SERVICE BULLETIN # 1089

SUBJECT **GEARCASE MOUNTING WASHERS**

MODEL **1-60, 1-80** DATE 3/30/60

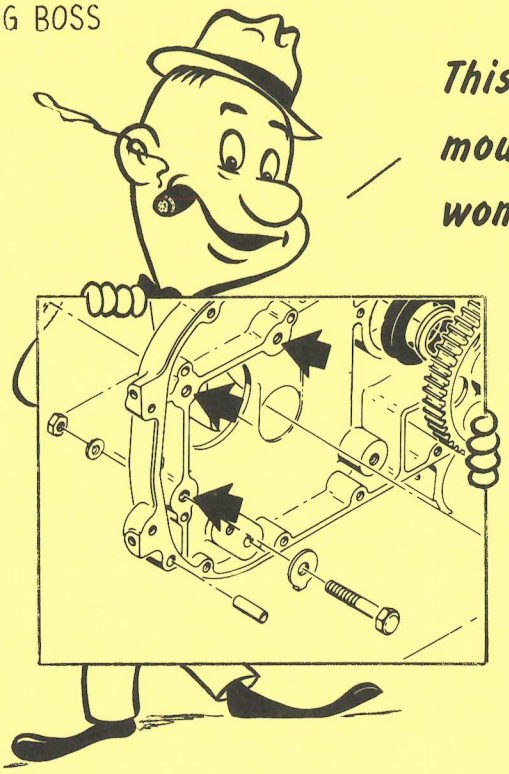
When repairing Model 1-60 and 1-80 transmission assemblies, add a flat washer, P/N 100311, under each lockplate on the three gearcase mounting bosses. This will prevent the gearcase mounting screws from crushing the bosses.

This shows the location of the mounting bosses. Your customers won't mind the cost of the three additional washers when you point out the advantages of preventive maintenance.
